Sidewalk Application Package

DINING OUT NYC

COMMUNITY BOARD RECOMMENDATION FORM

Business Name: THE BLUE MEZZE BAR						
Cafe Address: 1480 2 AVENUE, NEW YORK, NY, 10075						
Application Number: 20240612010001						
CB Review Deadline (on date or next business day): 8/9/2025						
NYCDOT Internal Use Only						
Sidewalk Cafe Setup Feedback: Community Board chooses to WAIVE review						
Comments related to the cafe's physical footprint and dimensions :						
Comments related to pedestrian flow (i.e., visbility, safety , potential crowding):						
Comments related to potential conflicts with existing curb use (i.e., planters, bike racks, bus stops):						
Please check one of the recommendations below, either approval , denial , or approval with modifications <u>relating to the above application</u> :						
Community Board recommends approval Community Board recommends denial						
Community Board recommends approval w/ modifications						
Recommended modifications (only if approved w/ modifications):

Sidewalk Cafe Site Plan Form

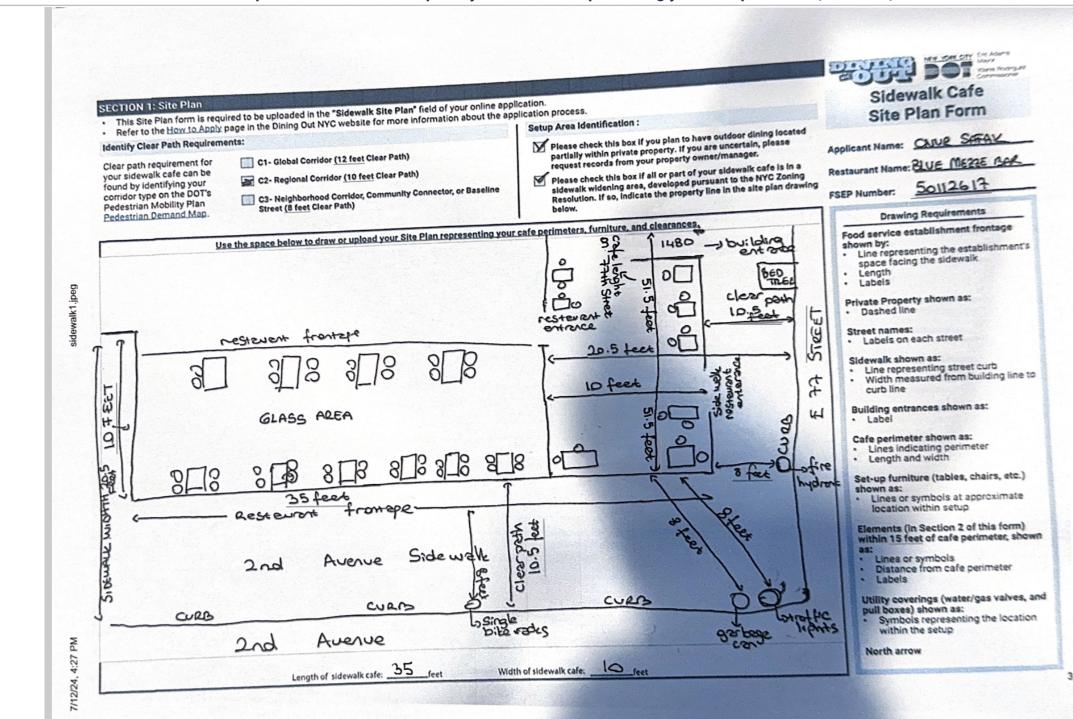
We can get you through but you will need to attest to a few missed items on the site plan form;

- All boxes must be checked off for "AWNINGS"
 - enclosed, permanent structures are not allowed
 - o affirming that you're in good standing with the Department of Buildings
- All boxes must be checked off for "OVERHEAD COVERINGS"

Perfect thank you. We removed the structure we had and is compliant now. I will fill out form and send back to you.
